RE: Sharon W.S.C.
Application to Amend Water CCN (10476)
PWS ID# 2500020
Upshur County, Texas.
Docket #44816 – Order No. 6

SHARON W.S.C.
CCN AMENDMENT APPLICATION
WOOD COUNTY, TEXAS

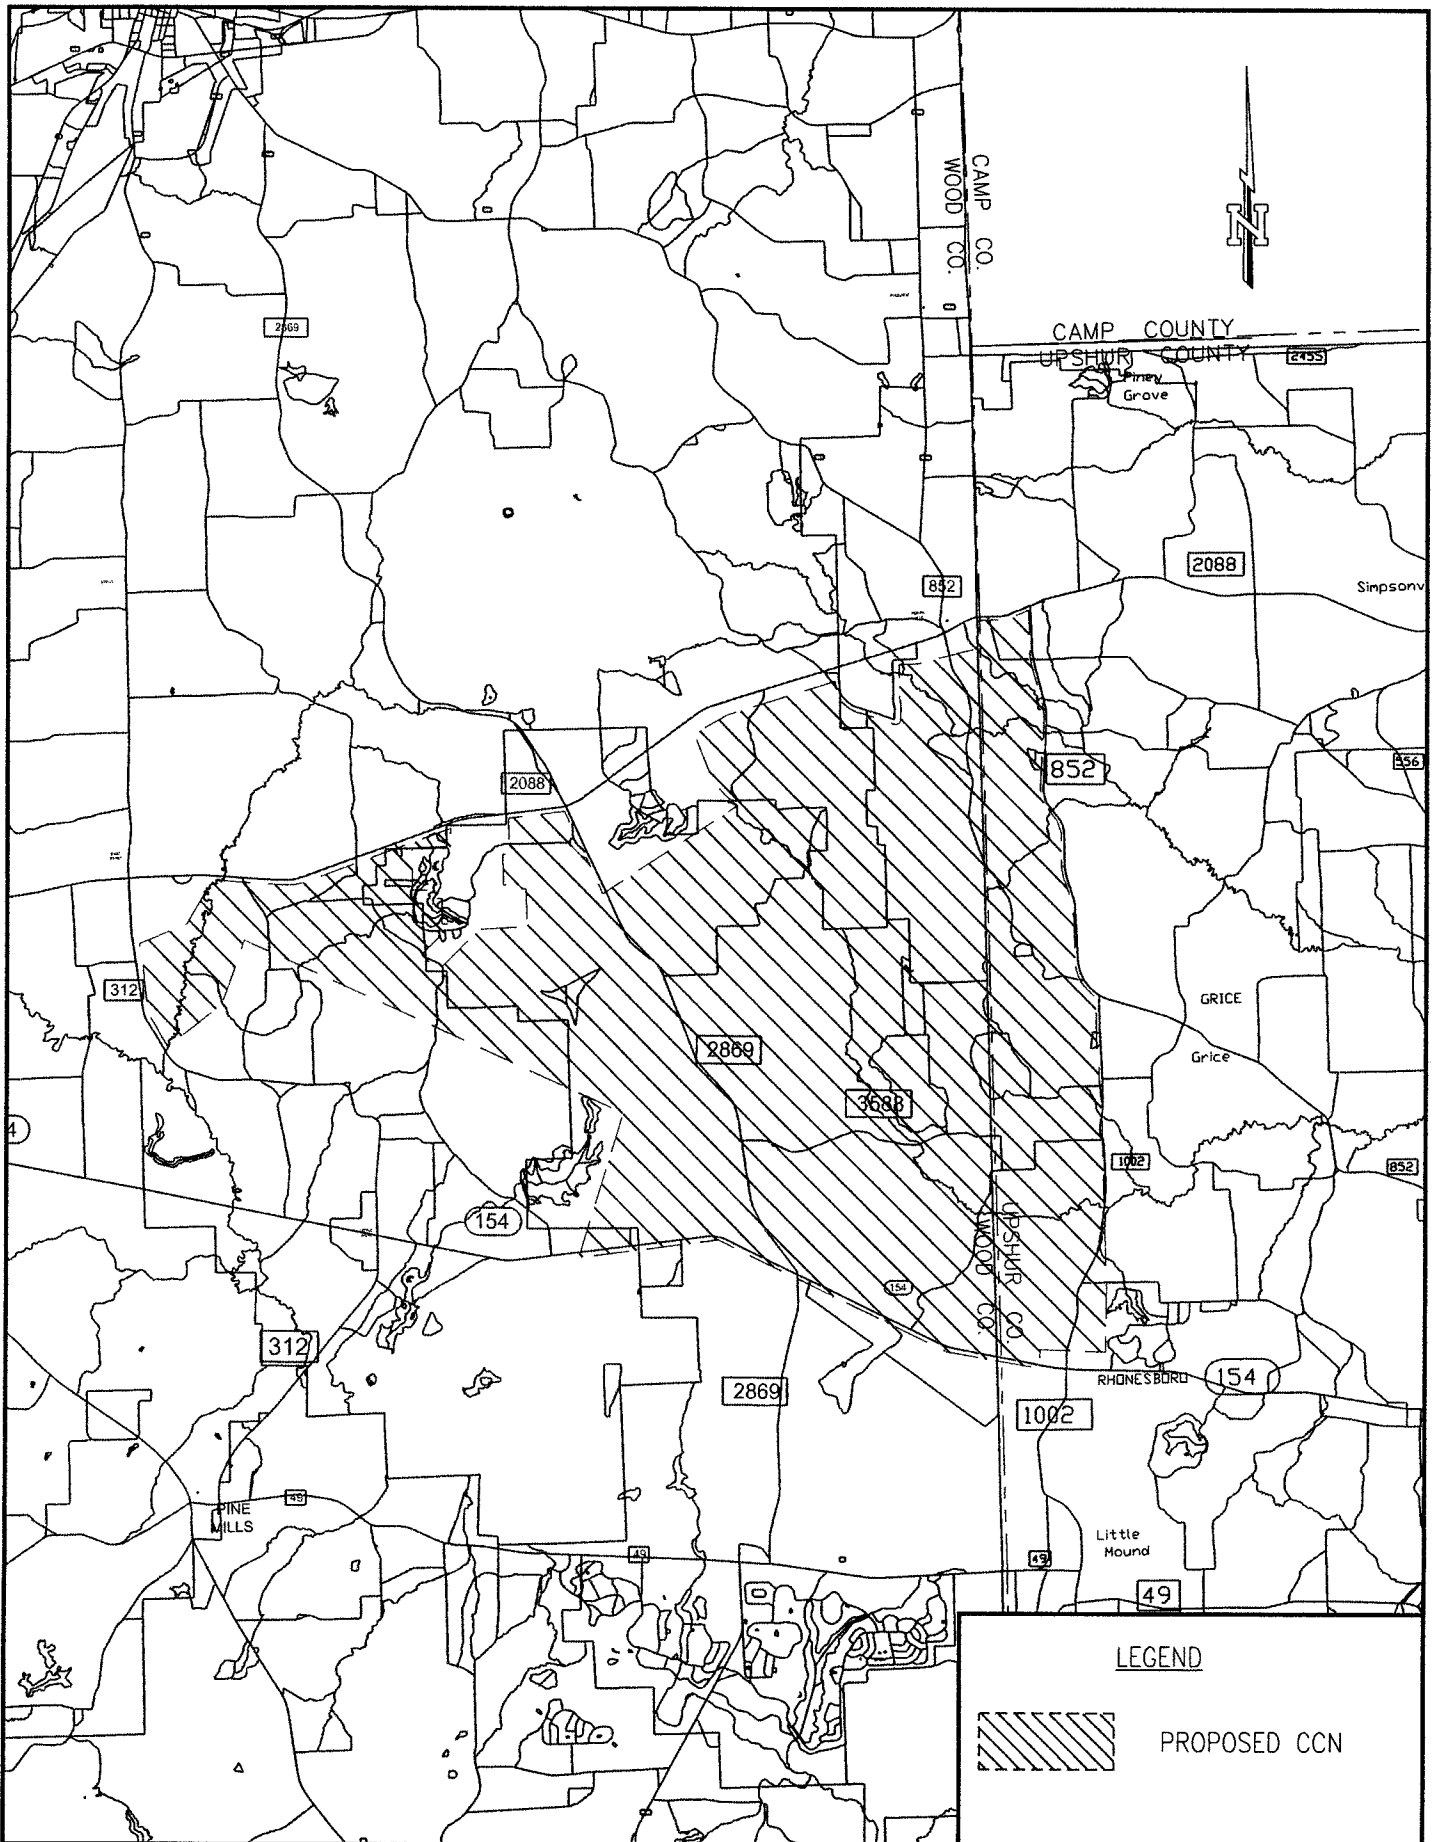
- 1.) A revised small scale (general location) map only showing the proposed water service area with enough detail to locate the service area in the vicinity of the nearest town, city, or county.

- a. **A small scale map showing a general location of the proposed service area is attached.**
- 2.) A large scale (detail) map only showing the proposed water service area with enough detail to accurately locate the service area in the vicinity of surrounding roads, streets, and highways.
